**CITY OF EL PASO, TEXAS
AGENDA ITEM
DEPARTMENT HEAD'S SUMMARY FORM**

Contract Change Order Coversheet /Checklist City of El Paso Capital Improvements Department

CITY OF EL PASO CONSTRUCTION CHANGE ORDER

RFI #110: Electrical Services Issue

MONTANA RAPID TRANSIT SYSTEM
SAUL KLEINFELD - STATION 12 ELECTRICAL SITE PLAN

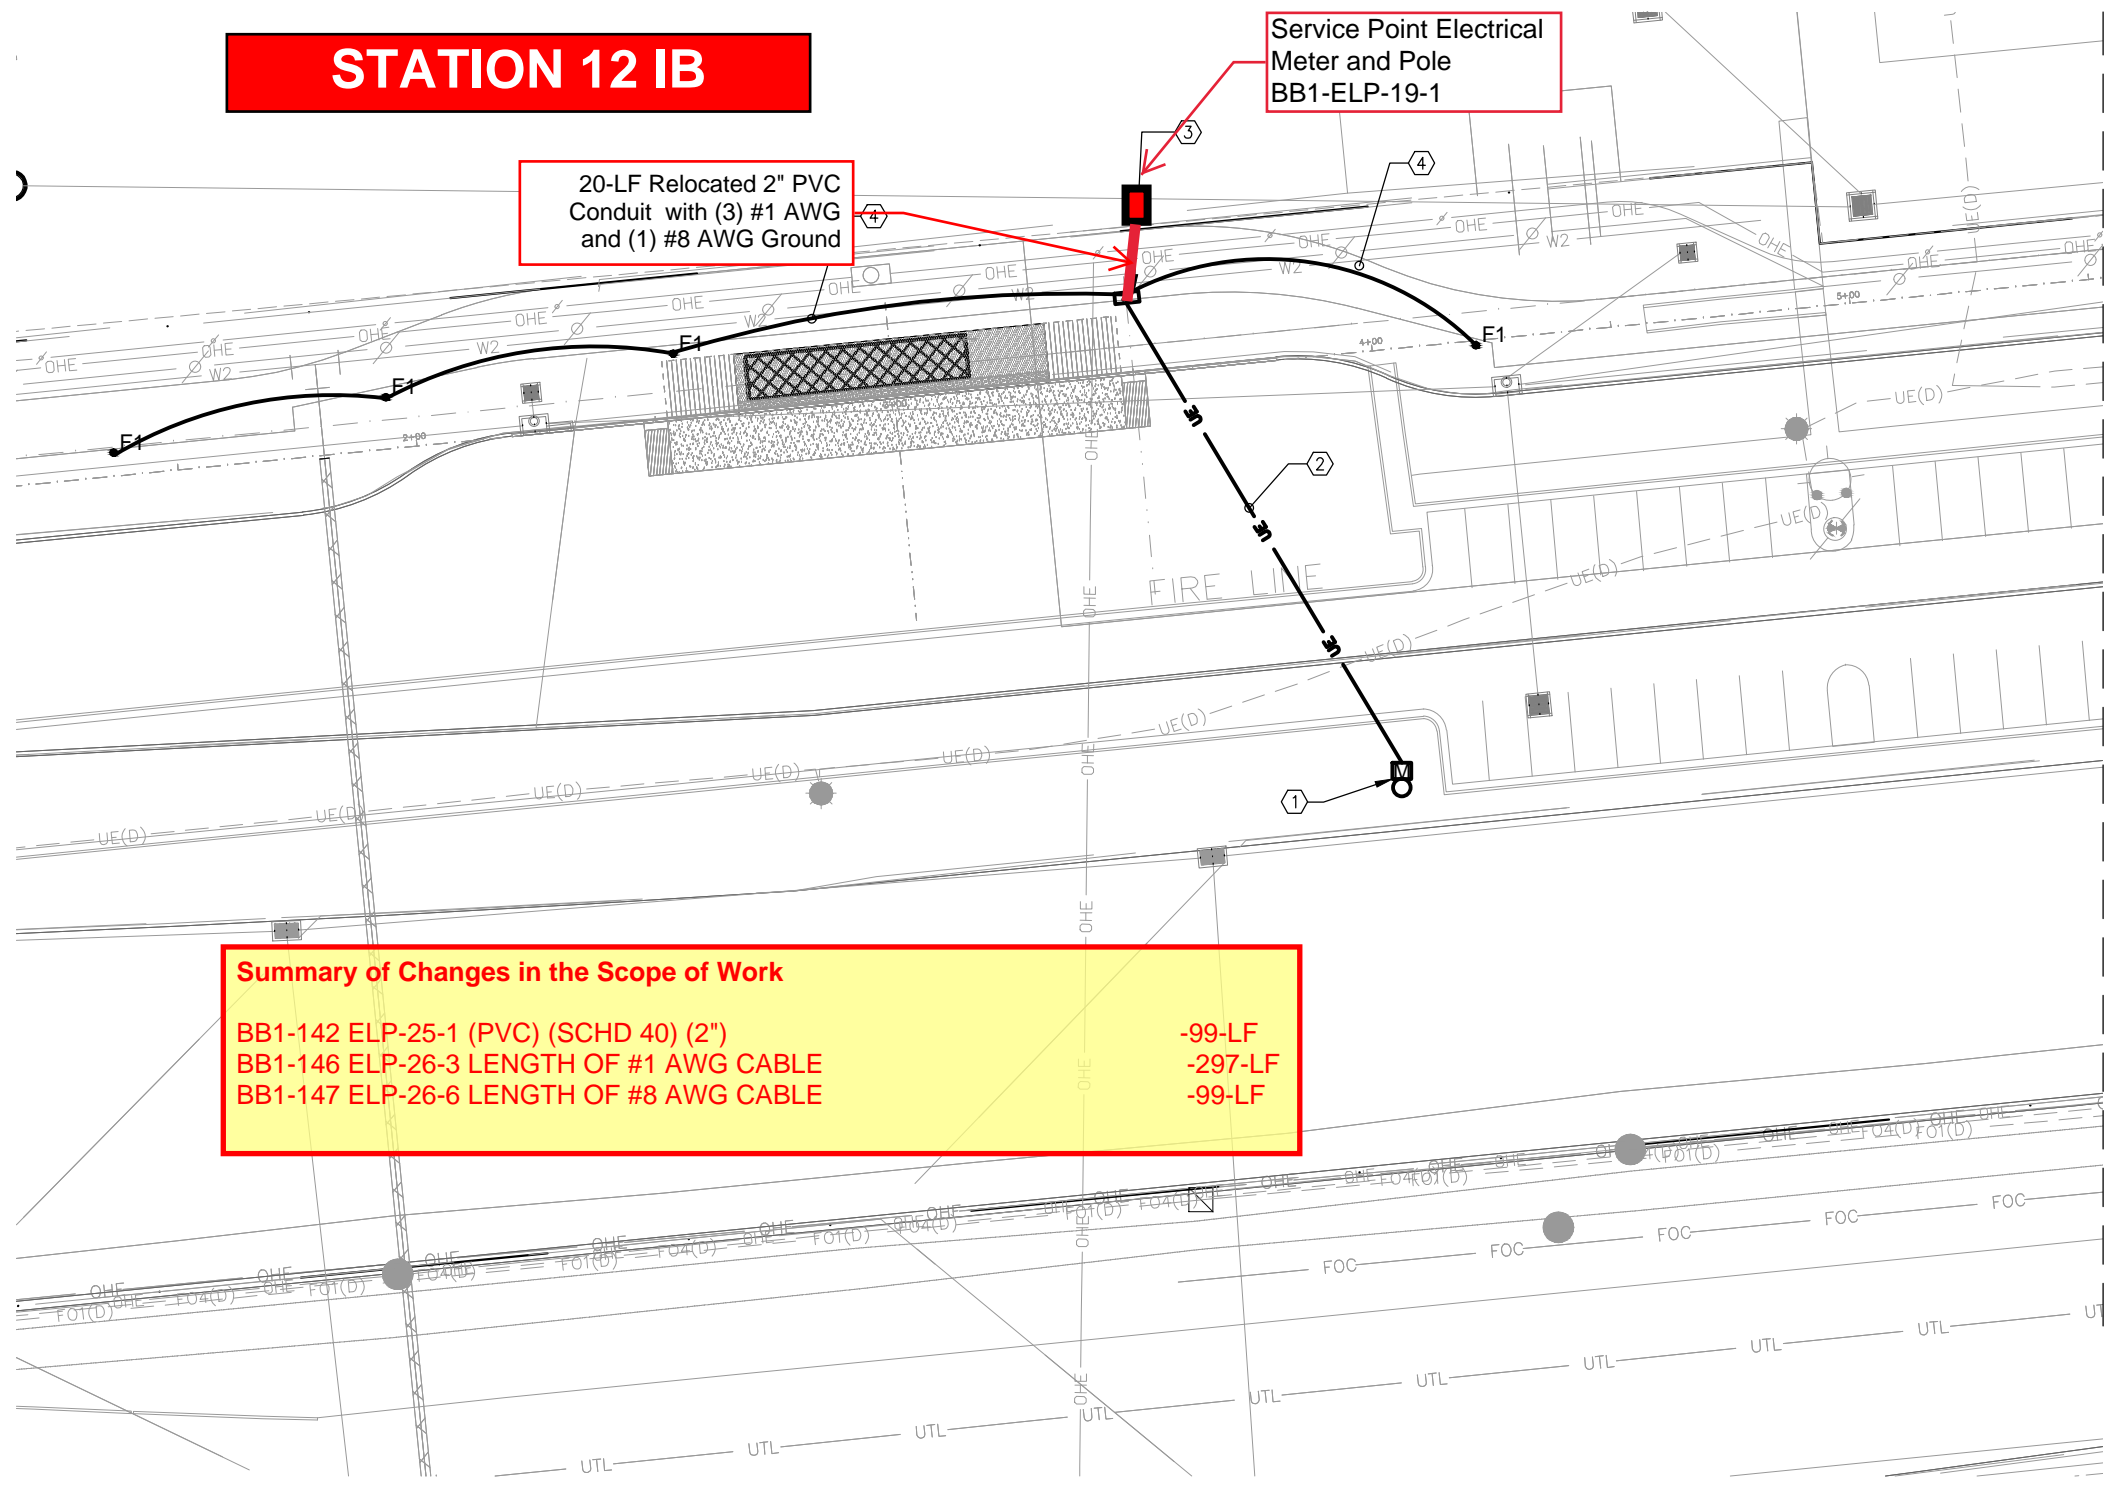
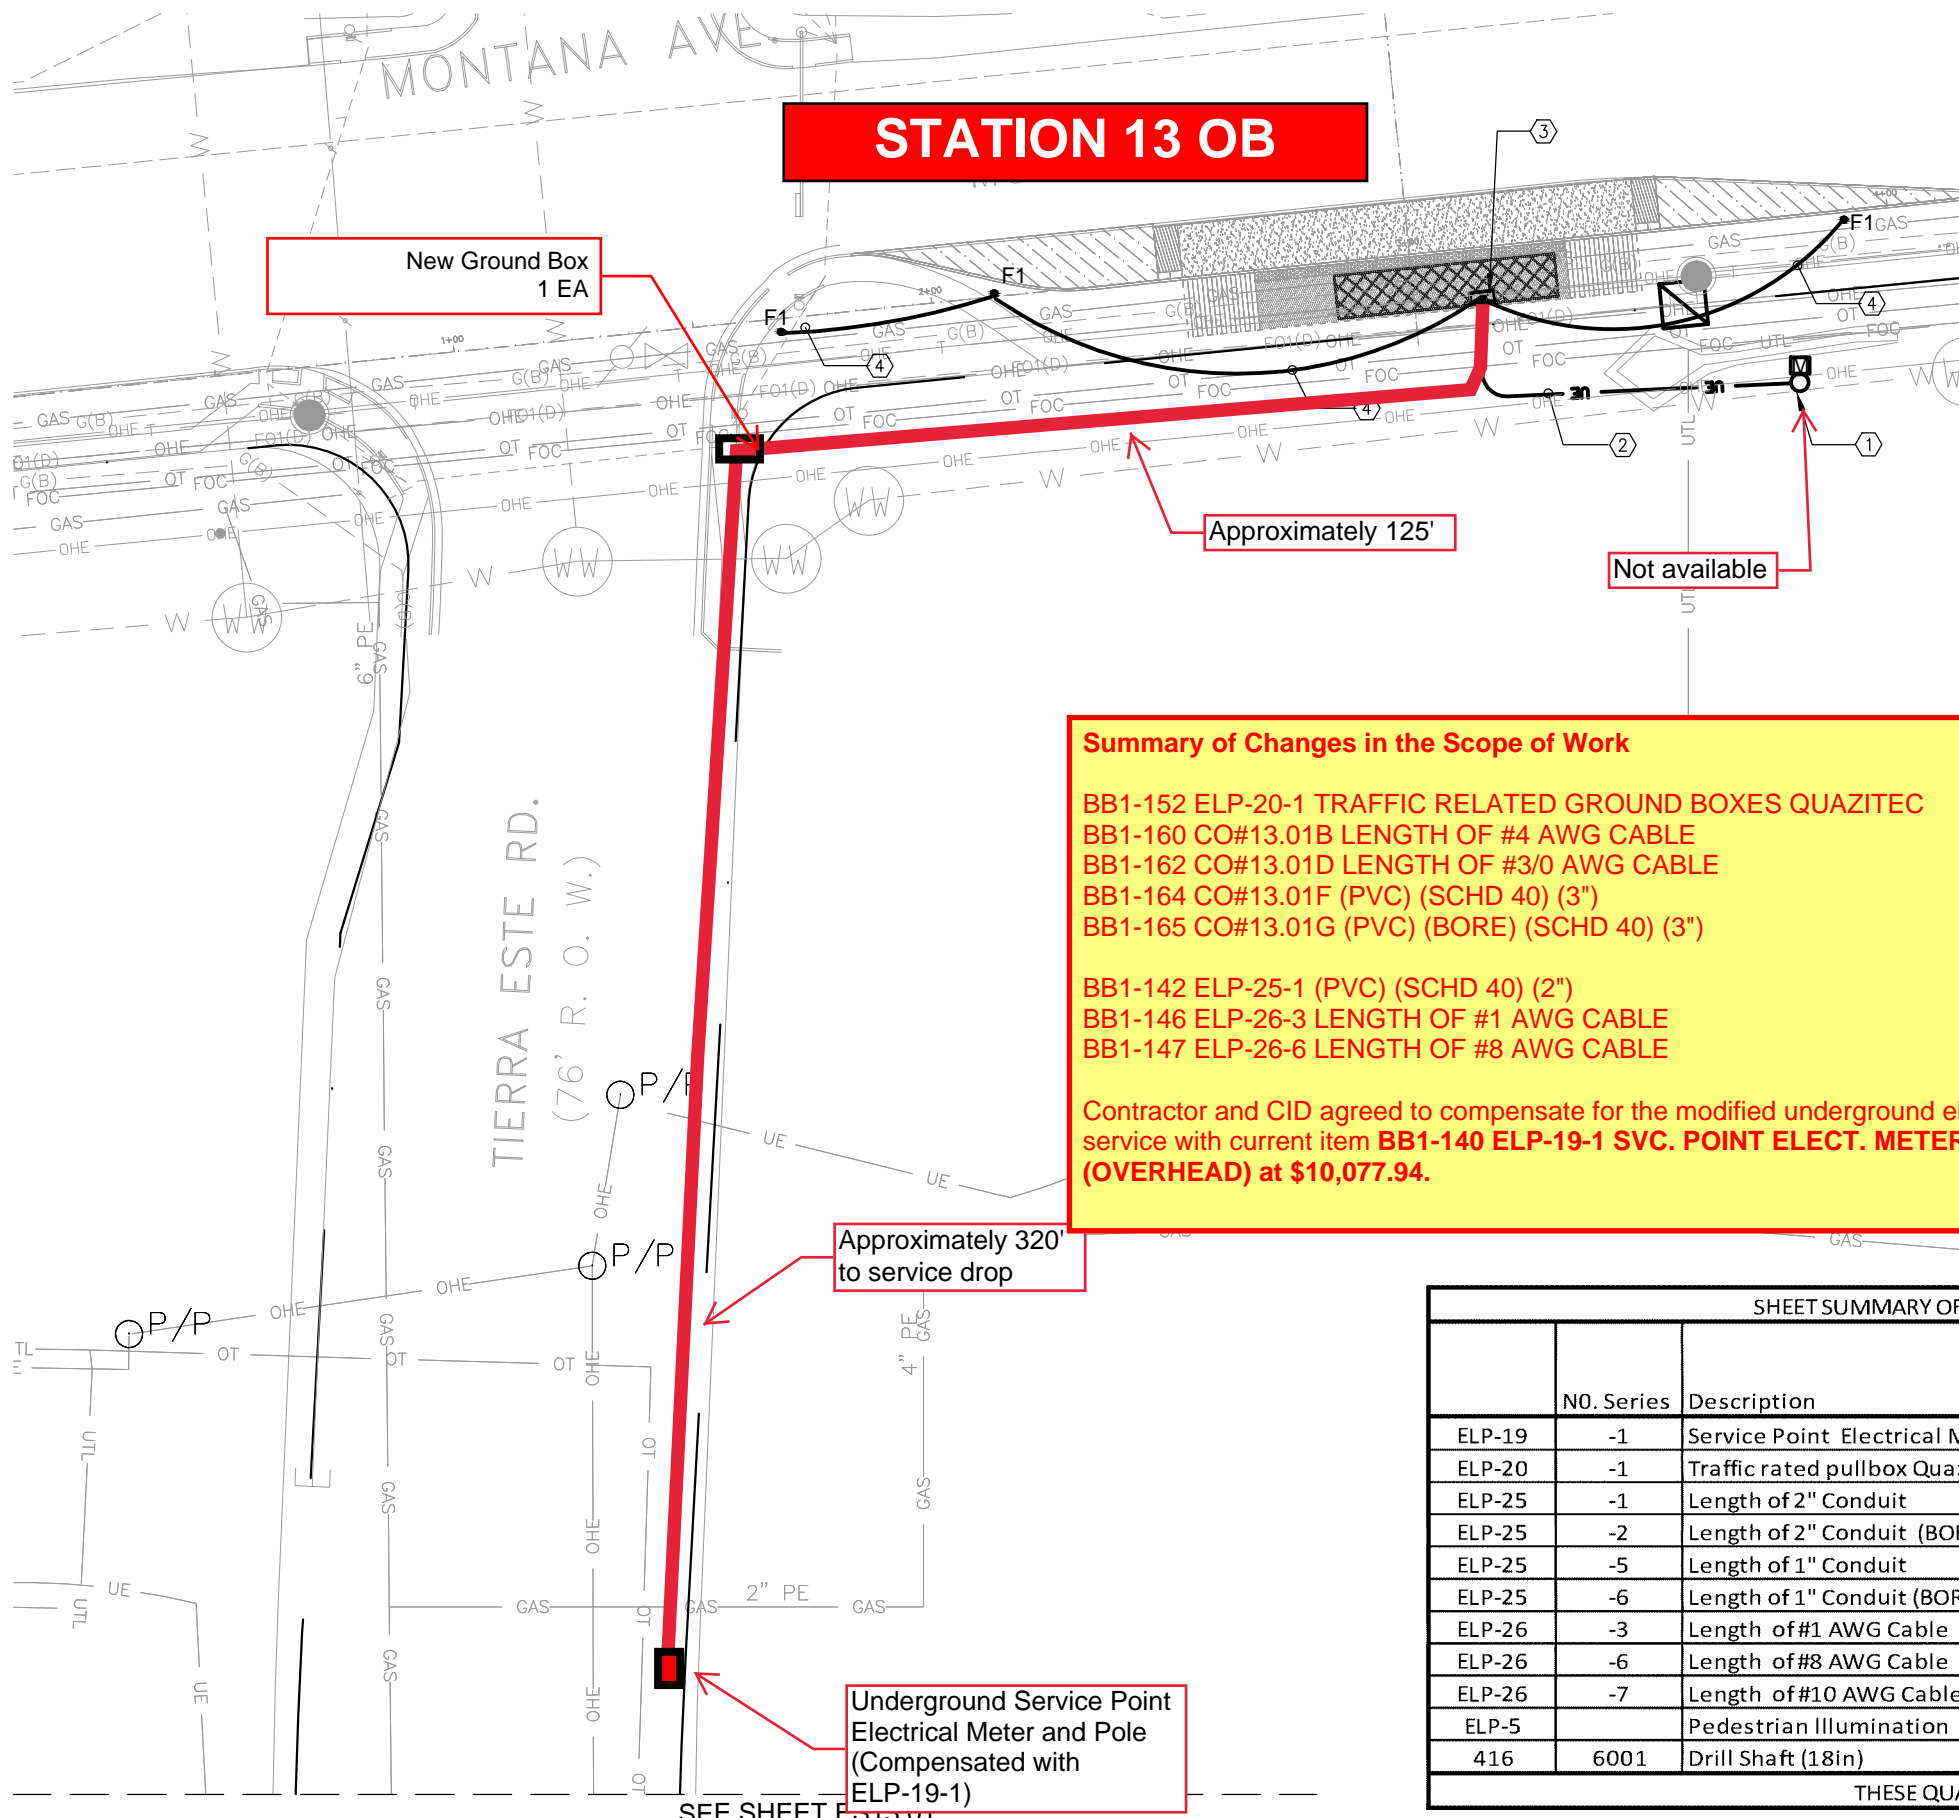
Contractor and CID agreed to compensate for the modified underground electrical service with current item **BB1-140 ELP-19-1 SVC. POINT ELECT. METER & POLE (OVERHEAD)** at \$10,077.94.

MONTANA RAPID TRANSIT SYSTEM
TIERRA ESTE - STATION 13 ELECTRICAL SITE PLAN

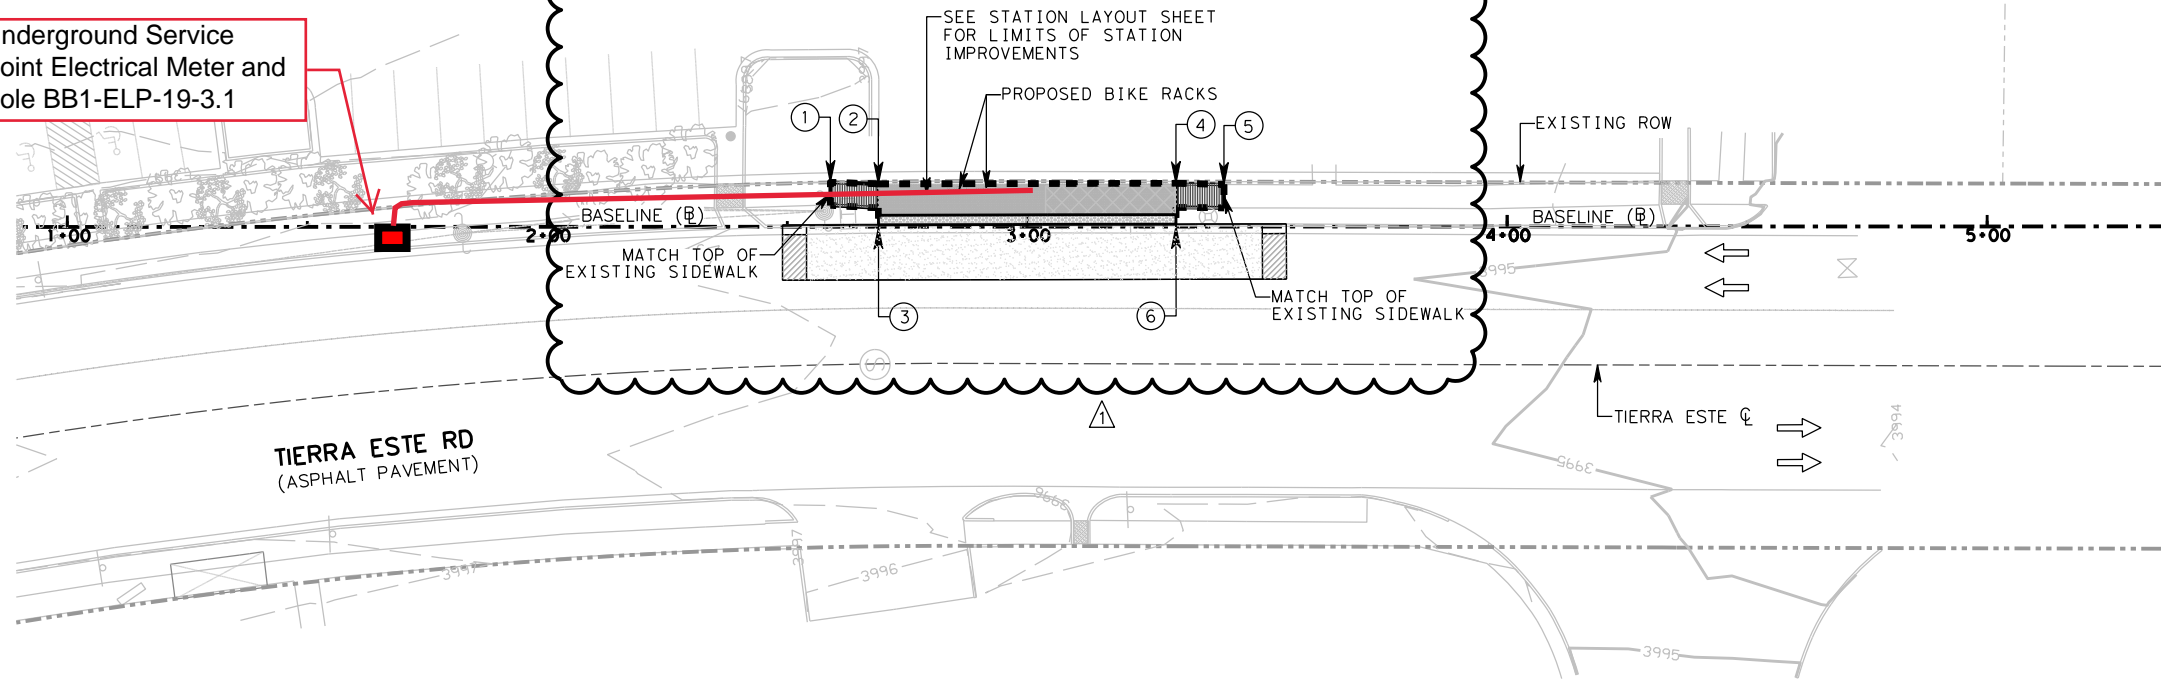
Contractor and CID agreed to compensate for the modified underground electrical service with current item ELP-19-1 SVC. POINT ELECT. METER & POLE (OVERHEAD) at \$10,077.94/EA. Not currently under BB2 but to be added via CO#13.

BB2-241 CO#13.011 SVC. POINT ELECT. METER & POLE (OVERHEAD) +1-EA

BB2-203 ELP-19-1 SVC. POINT ELECT. METER & POLE (OVERHEAD) -1-EA
